SUBJECT: Rezoning of Certain Properties in the Nanaimo Sub-area of the Grandview-Woodland Community Plan, and Related Plan Amendments

Stephen Bohus, BLA
Grandview-Woodland resident and renter

Please defer and delay any changes to
Grandview-Woodland Community Plan (GWCP):

Plan is not followed:

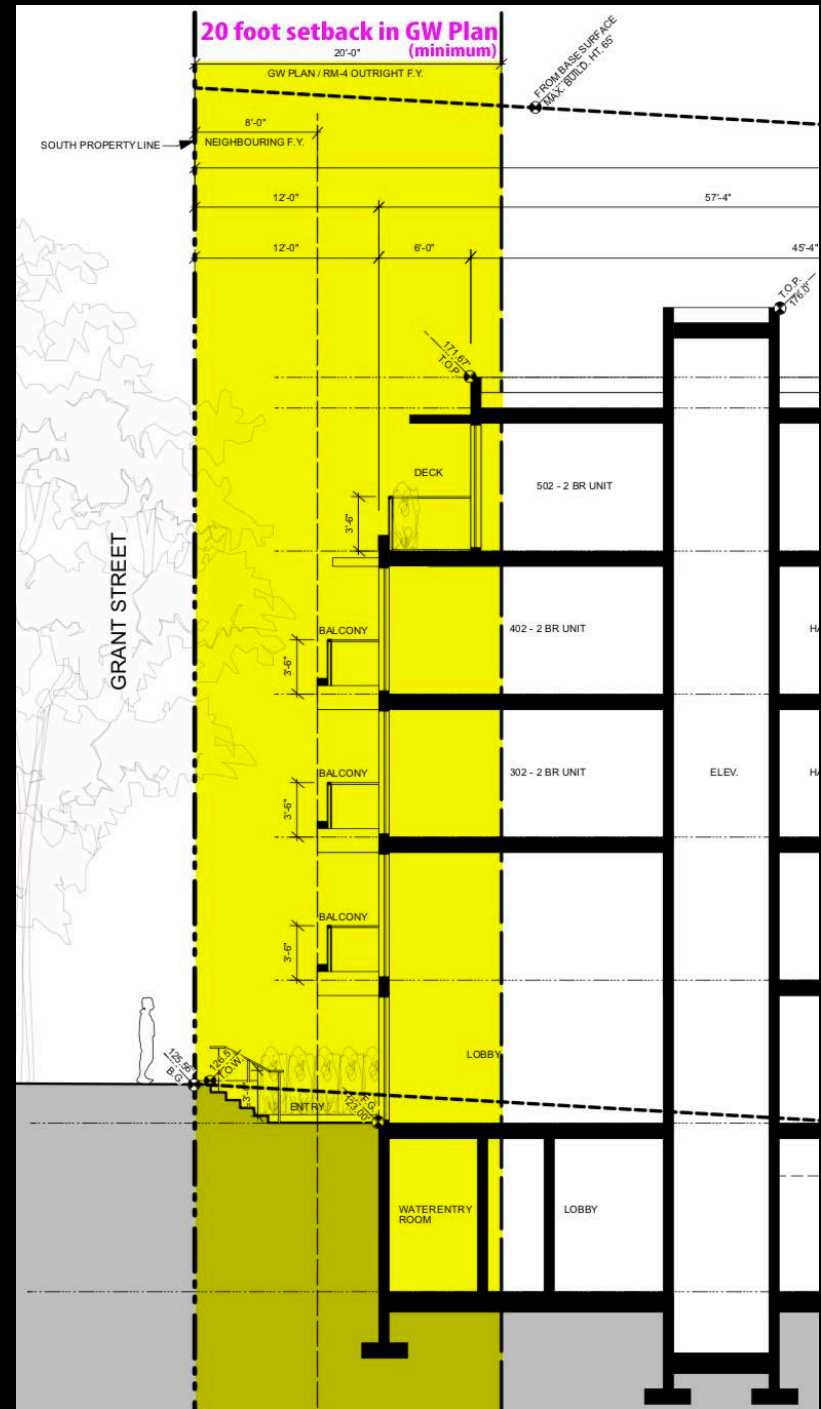
The minimum requirements listed in the policy for consideration for rezoning in the Grandview-Woodland Community Plan are simply not met. Section 6.4.1 applies to this site in Britannia Woodland (residential core, policy from p. 82):

Setbacks: Front 6m (20ft.)

Application had a 12ft. Front yard setback

- Height: up to 6 storeys. [L] [SEP]
- Density: up to 2.4 FSR. [L] [SEP]
- Site frontage: 15.1 m (49.5 ft.) (minimum) to 61 m (200 ft.) (maximum). [L] [SEP]
- Setbacks: **Front 6m (20ft.)** / Side 2.1m (7ft.) / Rear 6m (20ft.). [L] [SEP]
- Require ground-level access for first floor units. [L] [SEP]

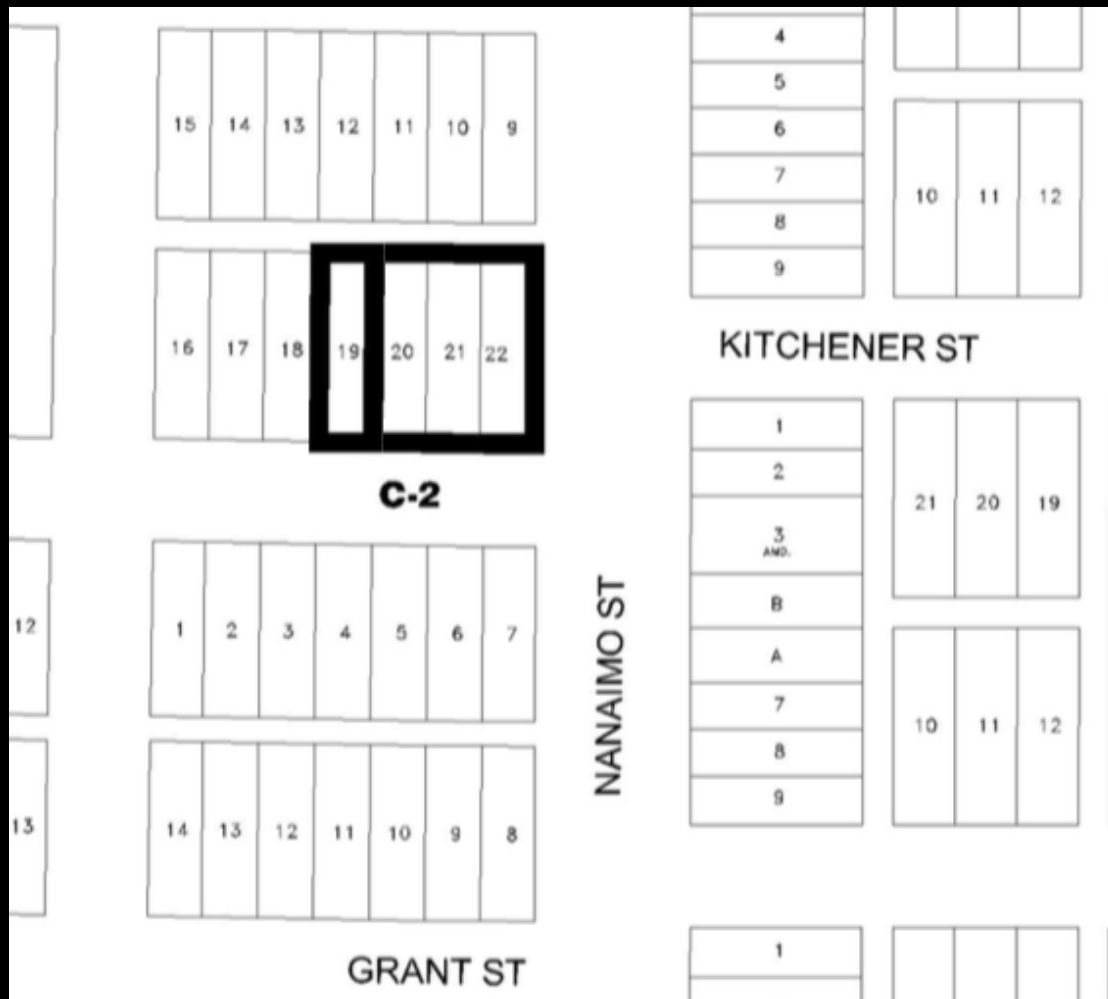
Laneway orientation from Kitchener (Nanaimo) on C-2 and laneway

C-2 should front 'main street' (Nanaimo); need for laneway at rear of C-2
